OUR TOWN HALL PROJECT

PROJECT STATUS	Riba Stage 5
CLIENT	Manchester City Council
PROJECT	Our Town Hall
DRAWING TITLE	Chimney Number CS06 Proposed repairs
SIZE & SCALE	A1: 1:20
DRAWING STATUS	S4 - Construction
JOB NUMBER	236959
DRAWING NO.	OTH-PUR-TH-RF-DWG-A-4166 02
REV

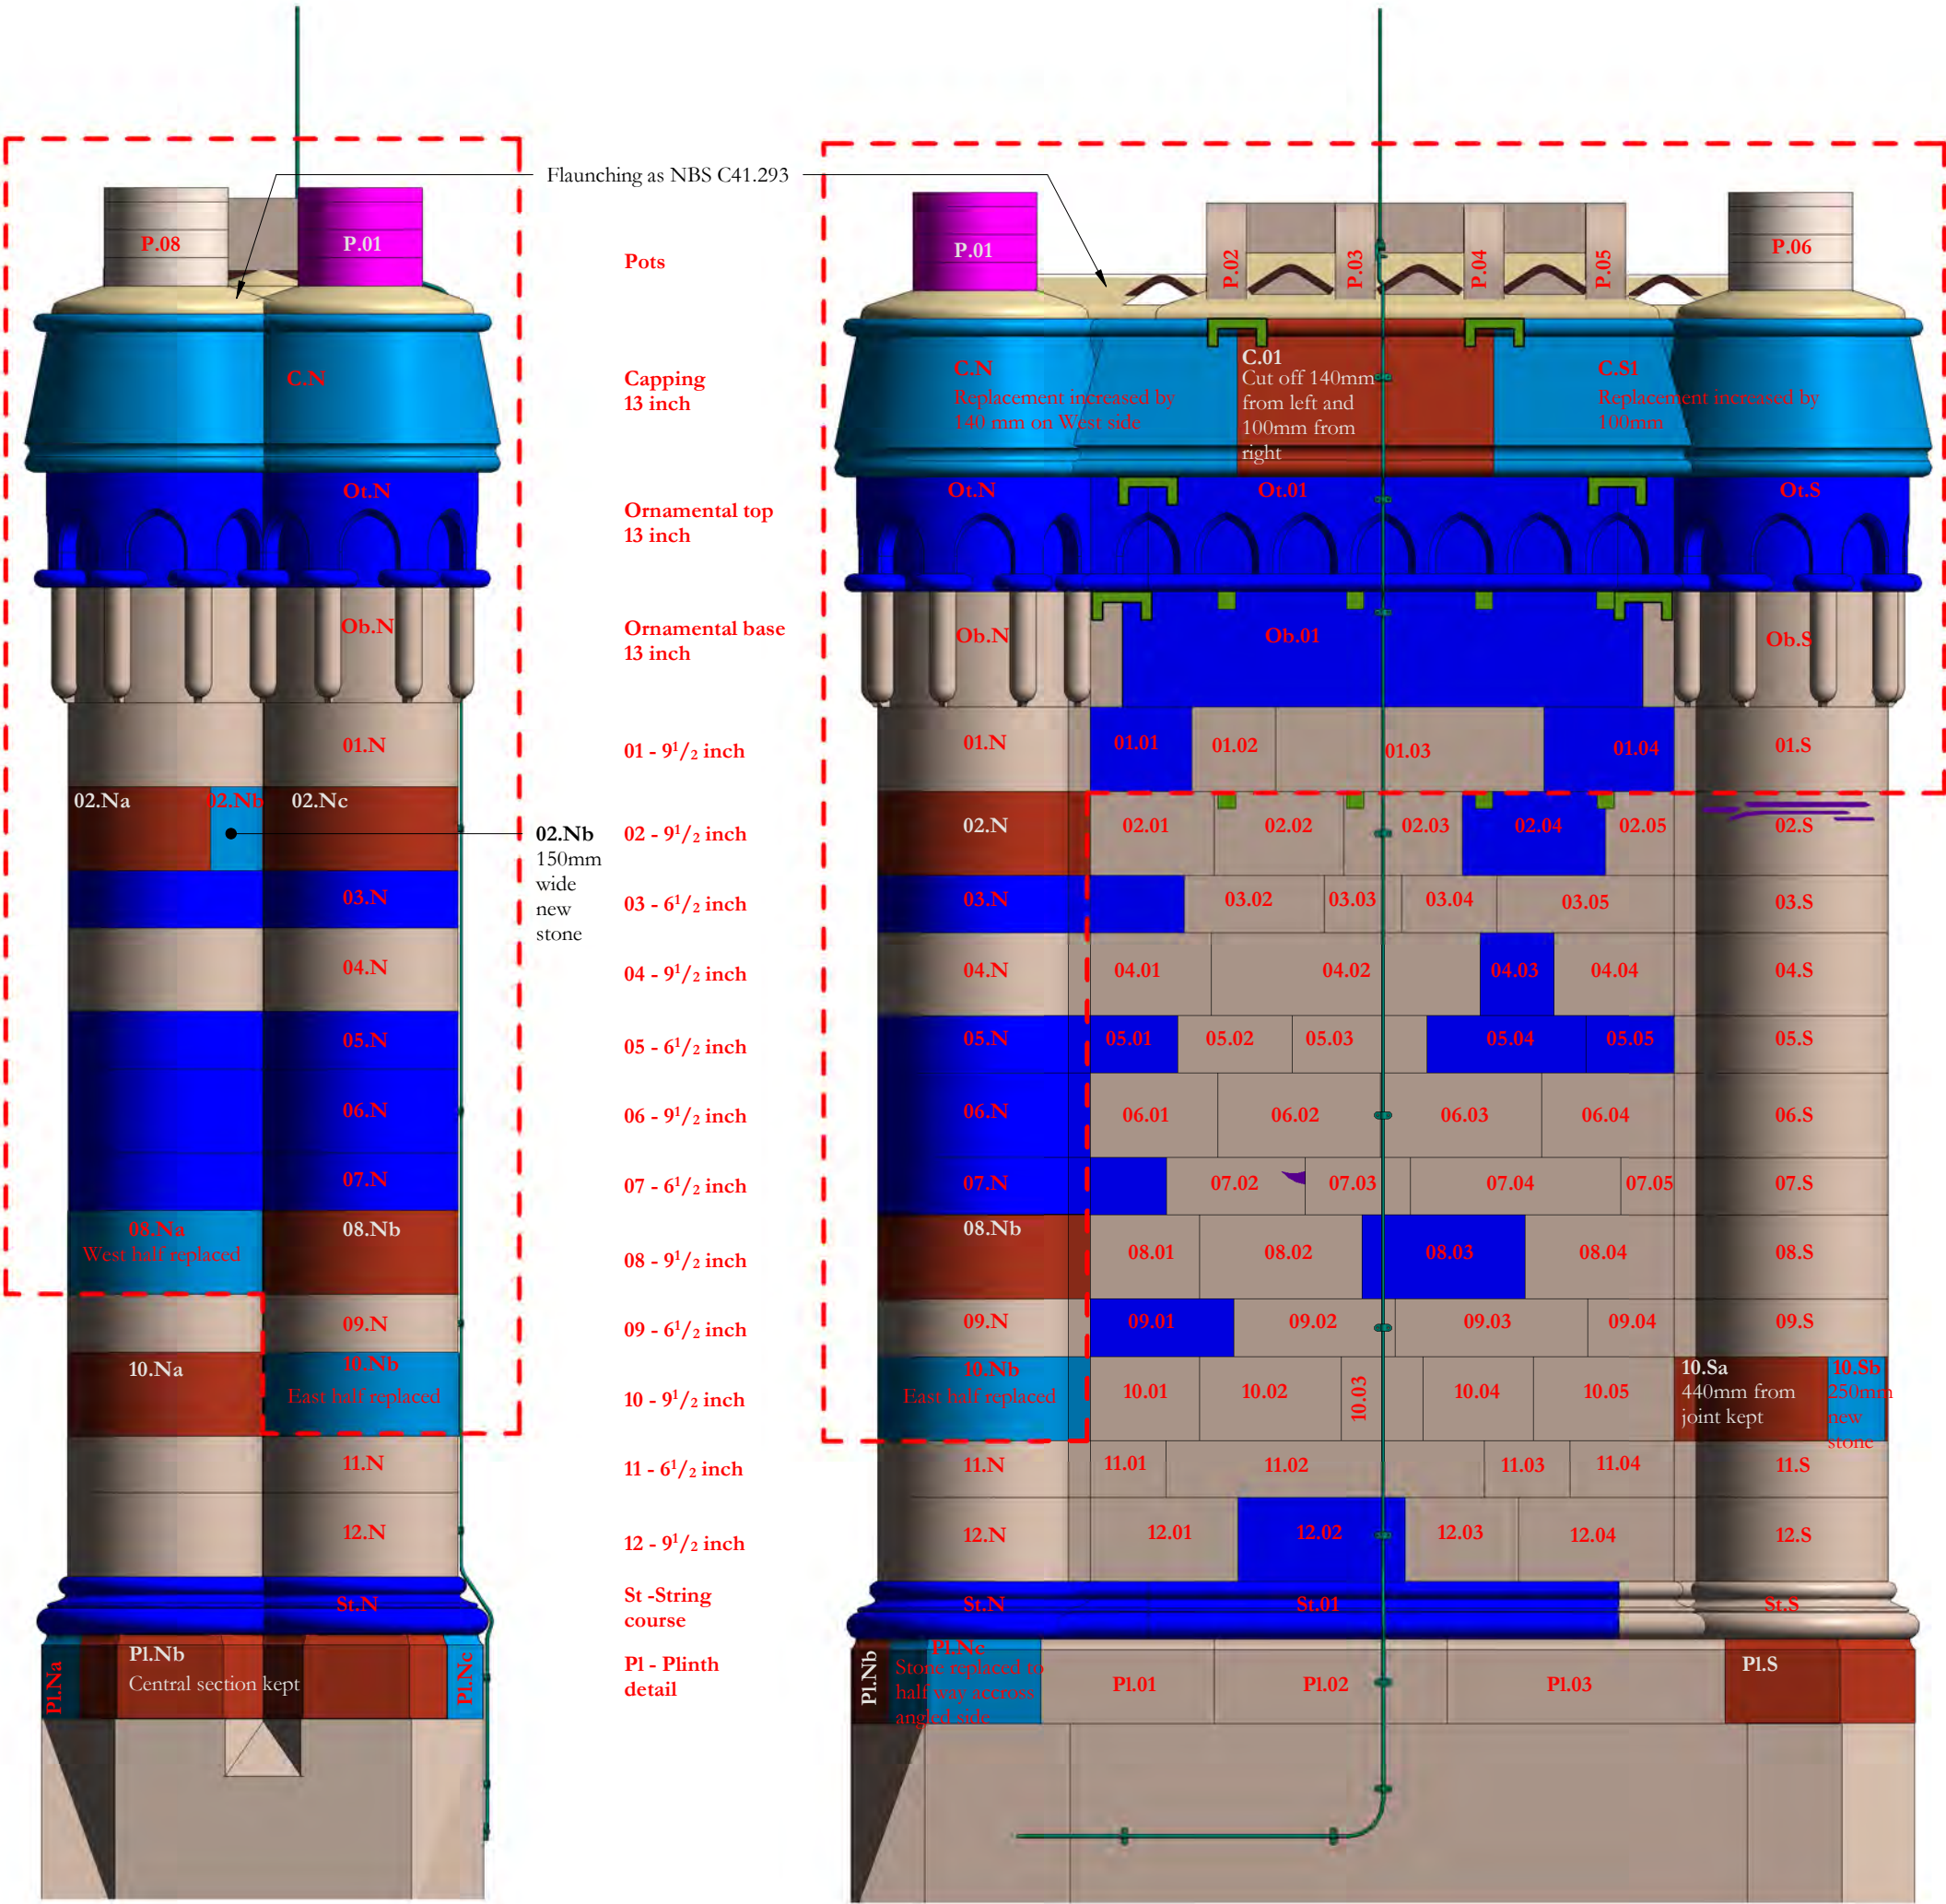
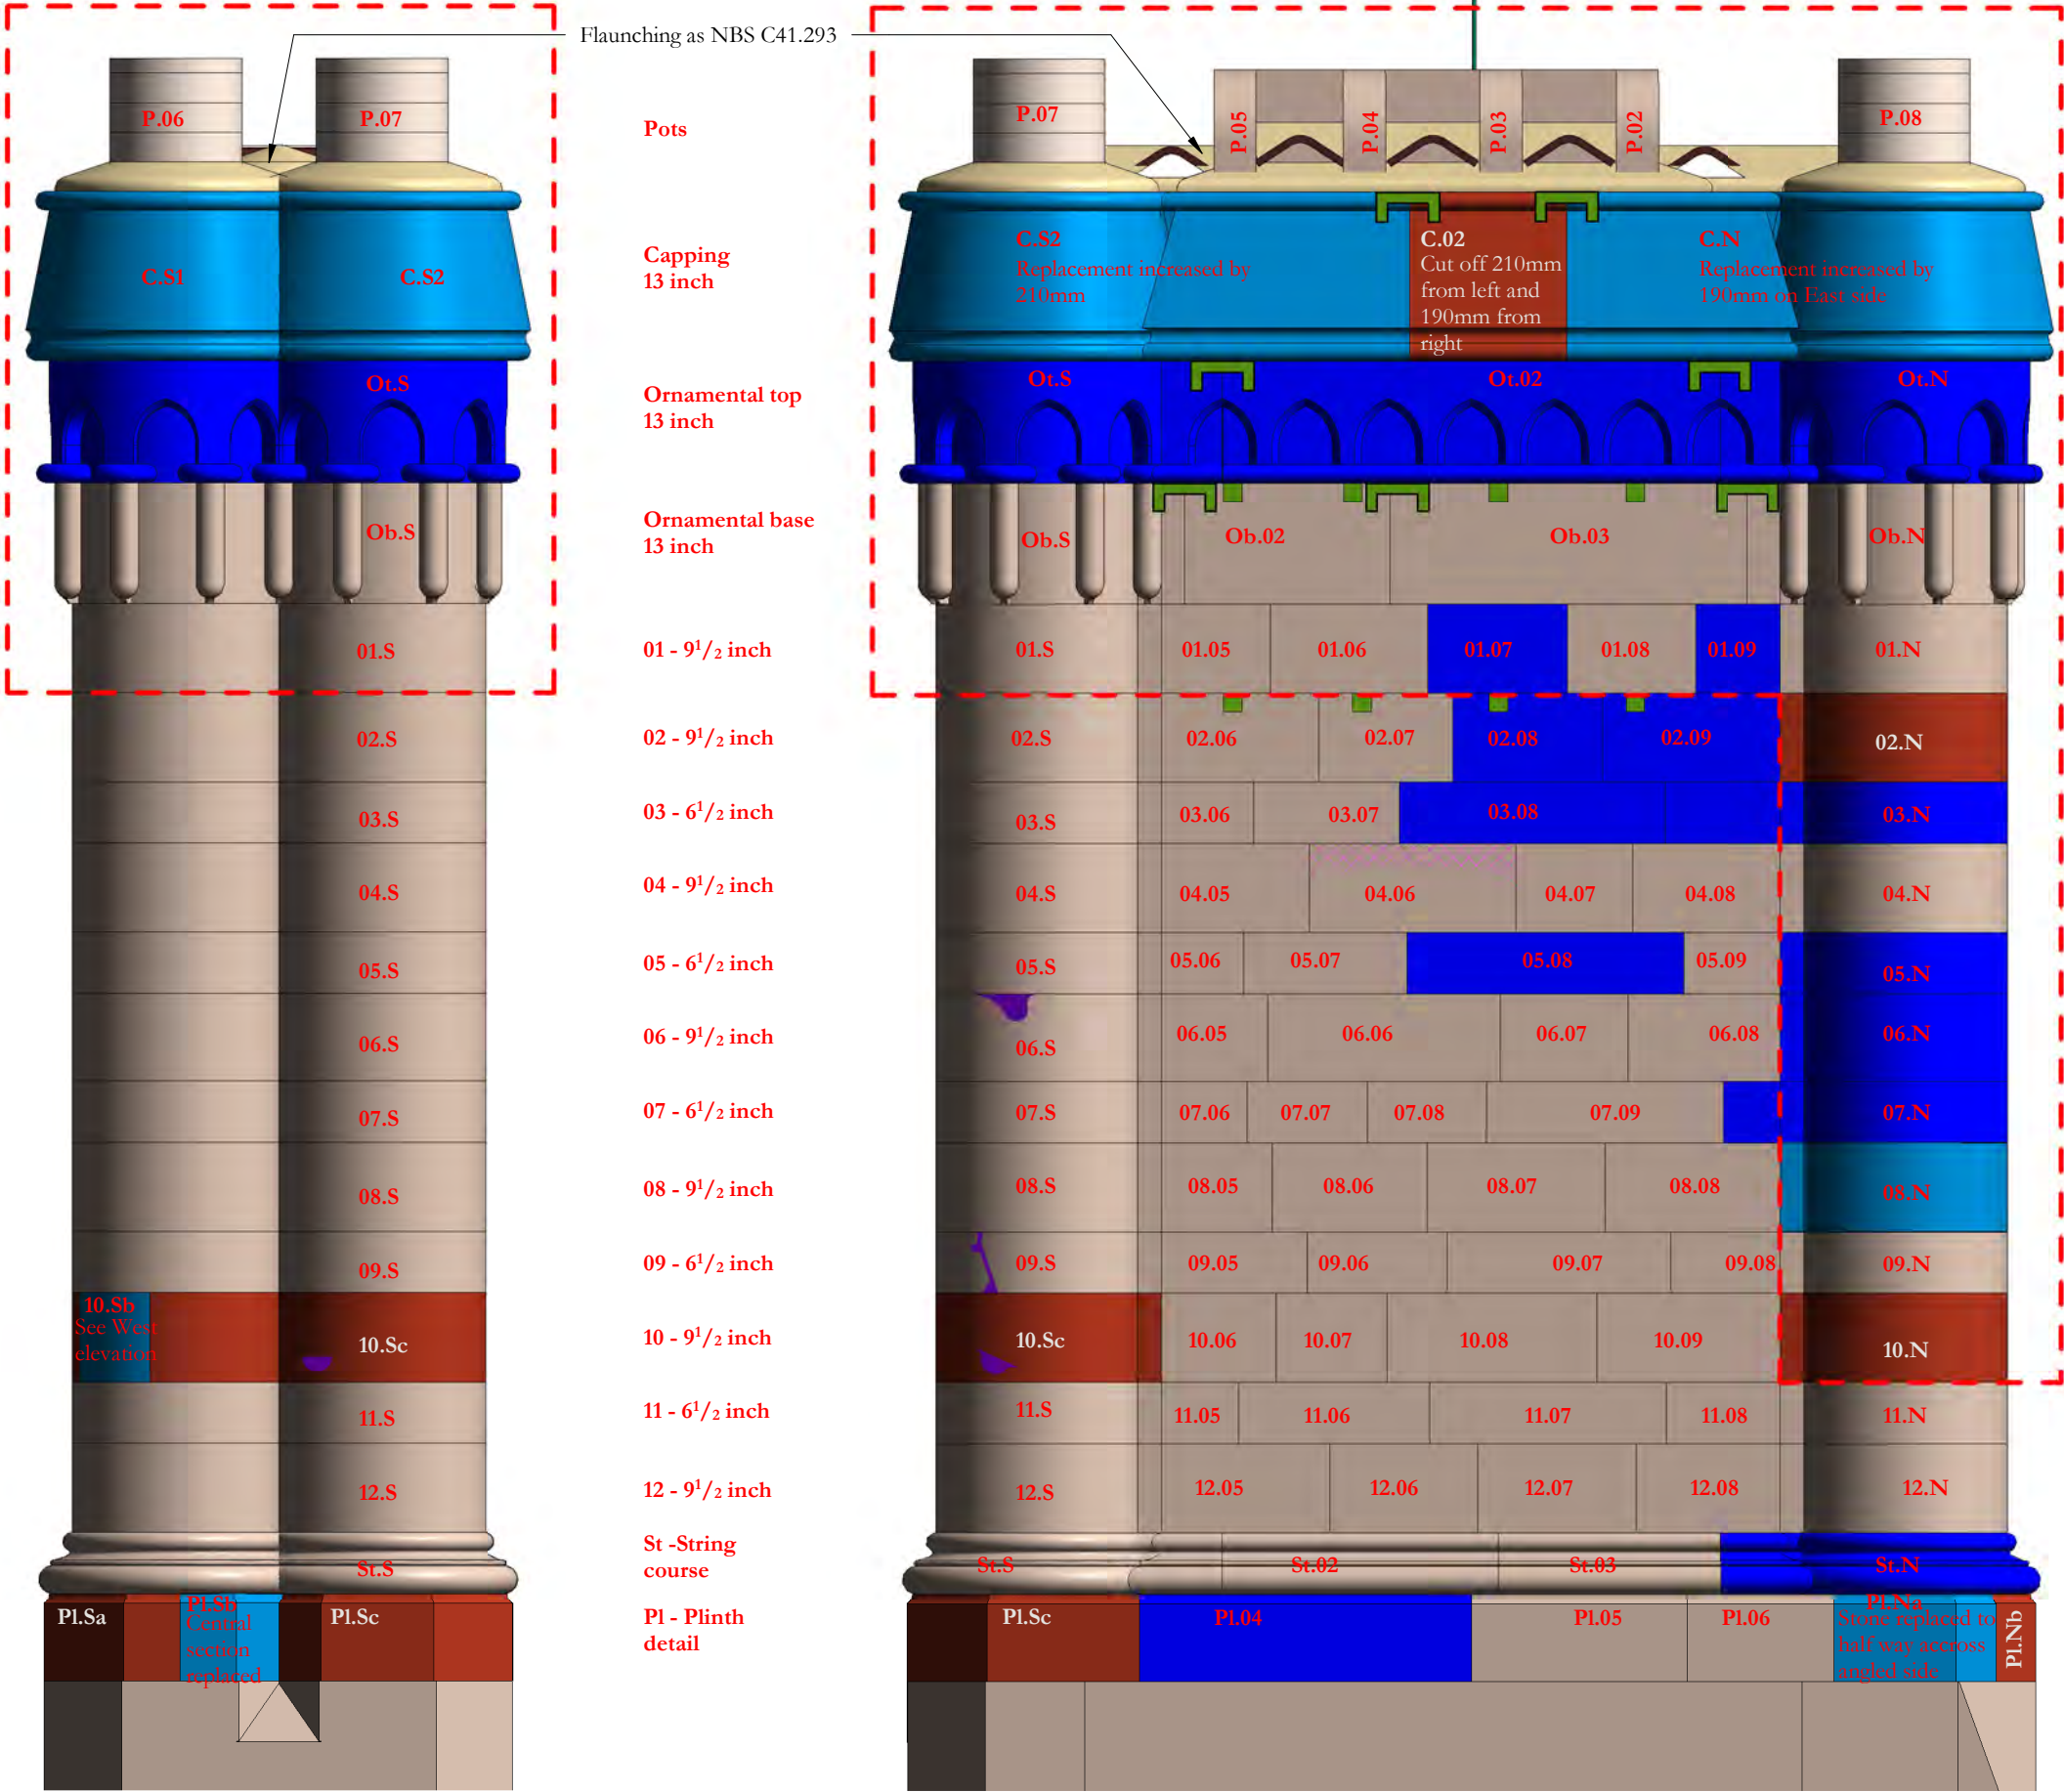
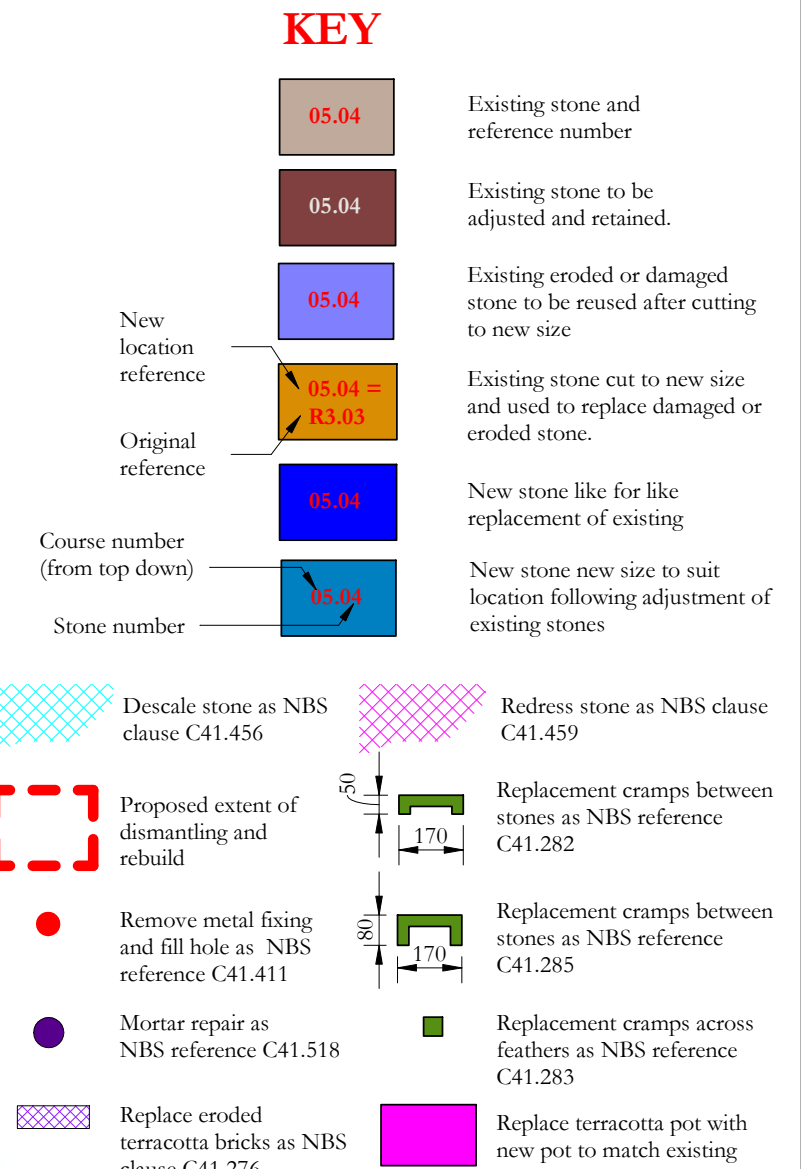
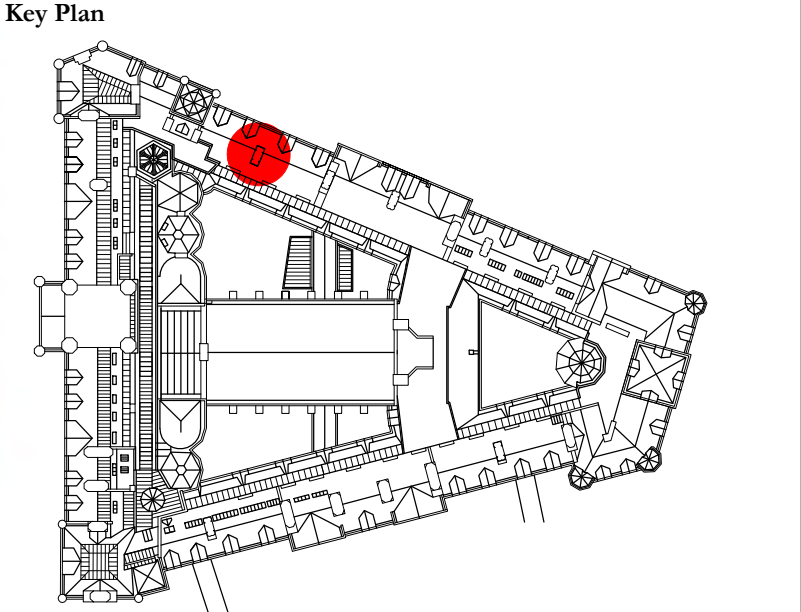
Revision 02: Circular flue component 07.N to be replaced and combined with 07.01 and 07.10 to form tie to main body of chimney. Components 03.N, 03.01 and 03.09 combined into one component to tie flue to main body of chimney. Bronze cramps added across feathers to section of chimney to be rebuilt. Lightning protection added.
